[Docket No. 83-ANE-14-AD; Amendment 39-14043; AD 83-08-01R2]

#### **Airworthiness Directives; Hartzell Propeller Inc. (Formerly TRW Hartzell Propeller) Models HC-B3TN-2, HC-B3TN-3, HC-B3TN-5, HC-B4TN-3, HC-B4TN-5, HC-B4MN-5, and HC-B5MP-3 Turbopropellers**

**ACTION:** Final rule.

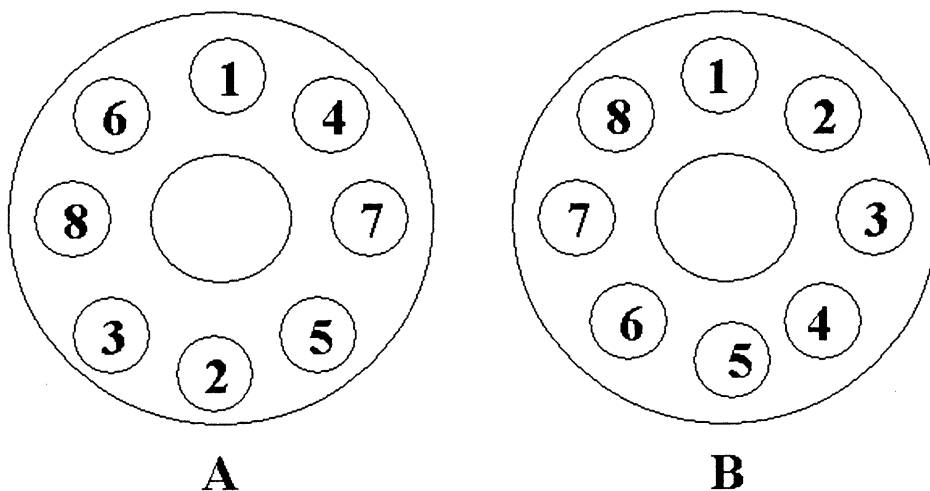
(5) Torque all attaching bolts with a torque wrench and an appropriate adapter, to 40 ft.-lbs., and then to 80 ft.-lbs., following sequence "A" (shown below). Final torque all attaching bolts using sequence "B" (shown below) to 100 ft.-lbs. to 105 ft.-lbs. Safety wire all attaching bolts in an FAA-approved manner.
